BID PACKAGE 01 – ADDENDUM 01

Date: November 22, 2019

Re: Wilma P Mankiller Health Center Expansion

From: James R Childers Architect, Inc.
45 South 4th Street
Fort Smith, Arkansas 72901

SHEET NUMBER: S1.21

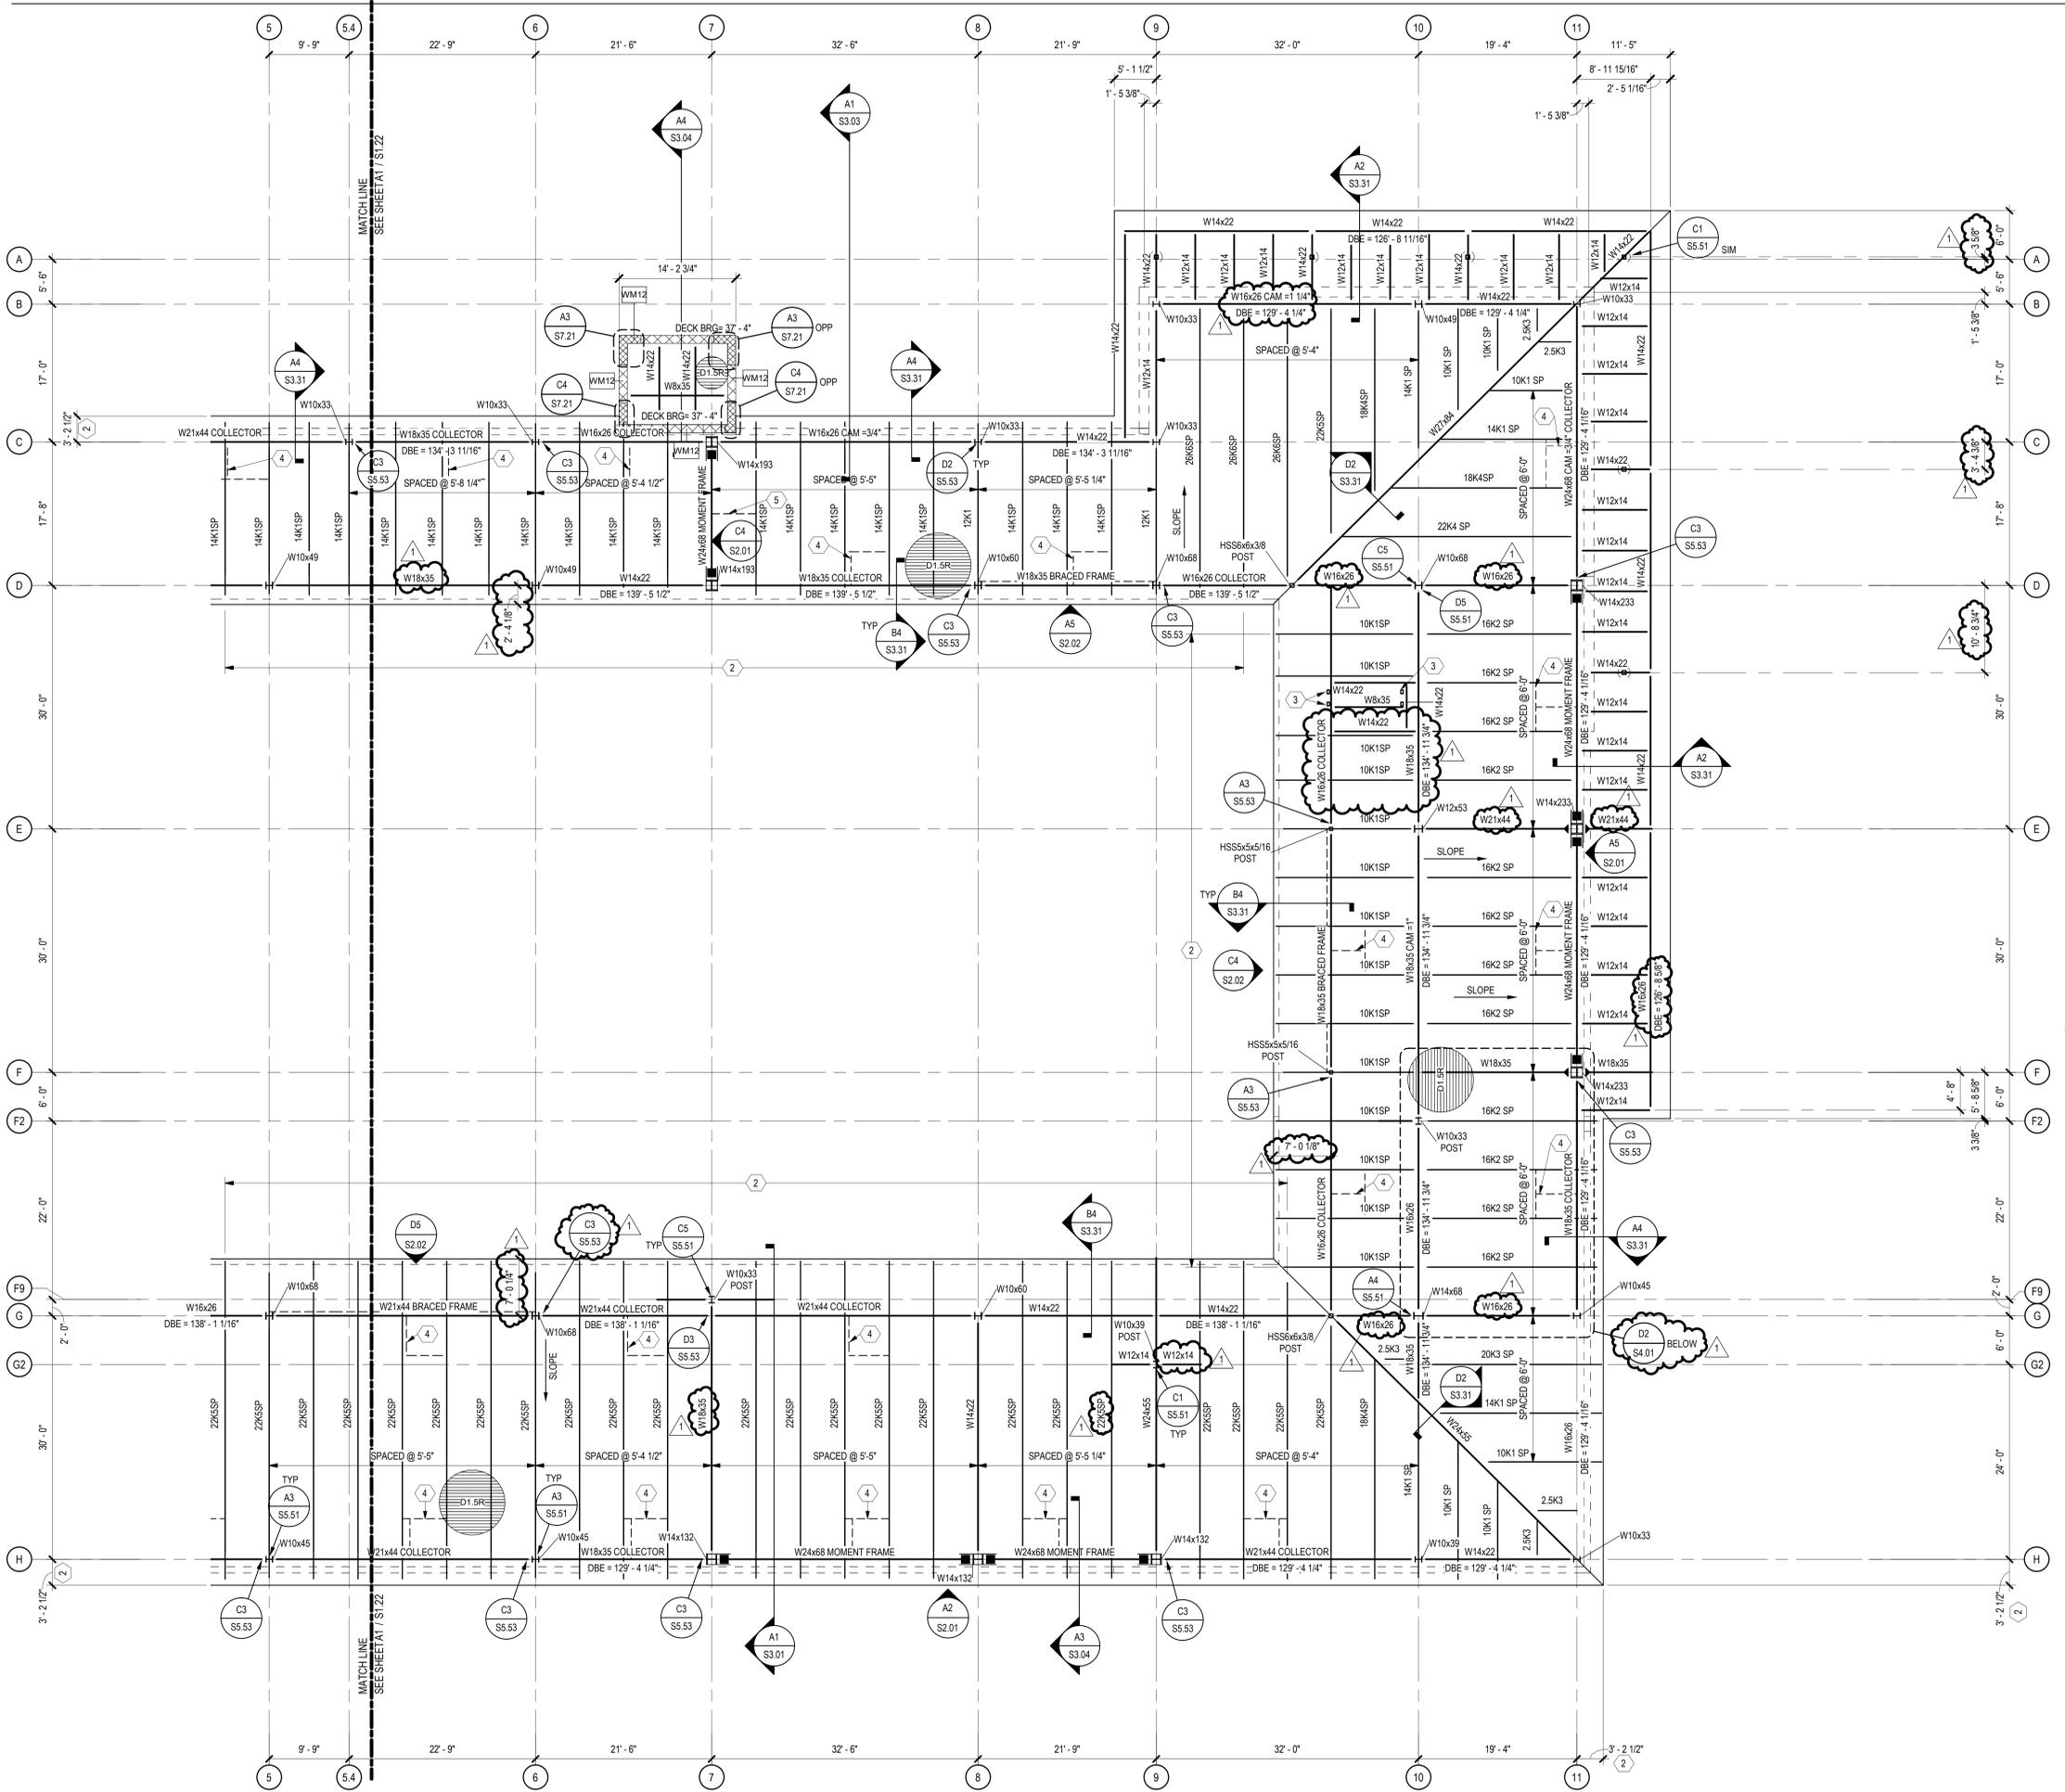
S1.12	Canopy/lobby area clarifying dimensions added near Grids A and C.
S1.12	Operable partition support beam sizes updated near Grid D, between Grids 1 and 2.
S1.12	Detail D3/S5.53 added near Grid H/2.
S1.13	Sheet keynote 12 revised.
S1.13	Snapping point between Grid E and D corrected.
S1.13	Beams/girders supporting rooftop mechanical units revised.
S1.13	Framing between Grid G/8 and F/10 revised.
S1.13	Connection details at Grid G/4 and D/7 revised.
S1.13	Beam removed and bottom flange bracing (keynote 8) added to moment frame beam at Grid F/3.
S1.13	Connection details updated at Grids E/4, E/6, D/7, and F/5.
S1.13	Bottom flange bracing (keynote 9) added to girders along Grid F and E, between Grids 4/5 and 6/7, respectively.
S1.13	Beam/bottom flange bracing added at post near Grid G/7.
S1.21	Clarifying dimensions and sections added around interior and exterior roof perimeter.
S1.21	Location of enlarged framing plan tag D2/S4.01 adjusted.

S1.21	Beam sizes near Grid G/11 revised.
S1.21	Beams added near post at Grid G2/9.
S1.21	Beam sizes near Grid E/11 revised.

S1.21 Beam sizes near Grid D/11 revised.
S1.21 Beam details revised at Grid B/9 and D/6.
S1.22 Sheet keynote 7 added.
S1.22 Clarifying dimensions and sections added around interior and exterior roof perimeter.
S1.22 Bottom flange bracing (keynote 4) added along Grids D and G.
S1.22 Joist size updates made along Grid 1, between Grids G and E.
S1.22 Beam size updates made near Grid E/1.
S2.01 SidePlate sheet numbers added to elevation key.
S3.03 Section A1 revised.
S3.11 Sections C3 and D2 revised.
S3.12 Section C4 added.
S3.31 Sections A5, B3, B4, D5, and D2 revised.
S3.31 Sections A1 and B1 added.
S4.01 Plans A3, D2, and D4 revised.
S5.21 Detail D5 revised.
S5.52 Details A5 and B5 revised.
S5.53 Detail C3 revised.
S5.54 Sheet added.
S6.01 Footing F60A information revised.
S6.01 Baseplate schedule information revised.
S6.01 Deck schedule information revised.
S6.01 Masonry opening information revised.
S7.21 Details A3 and D4 revised.

SHEET NUMBER: S6.01

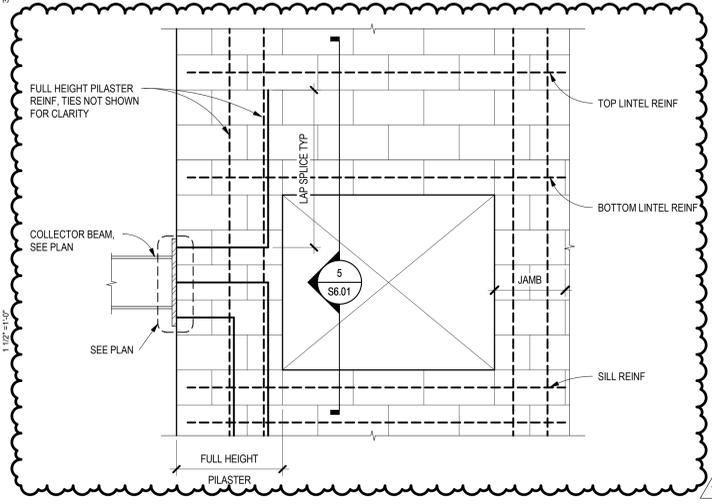
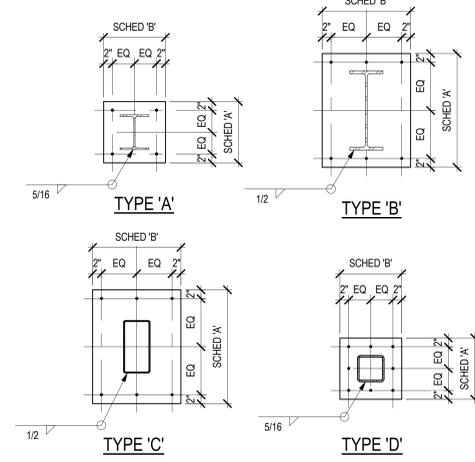
ENTIRE SHEET MODIFIED

C4 TYPICAL JOIST REINFORCING
SCALE: 1/2" = 1'-0"

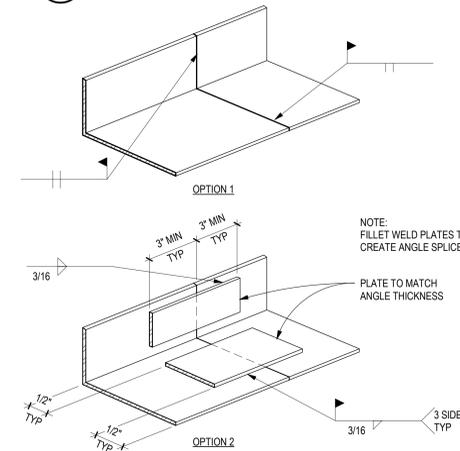
S7.31 Detail C3 added.
S7.42 Detail C4 revised.
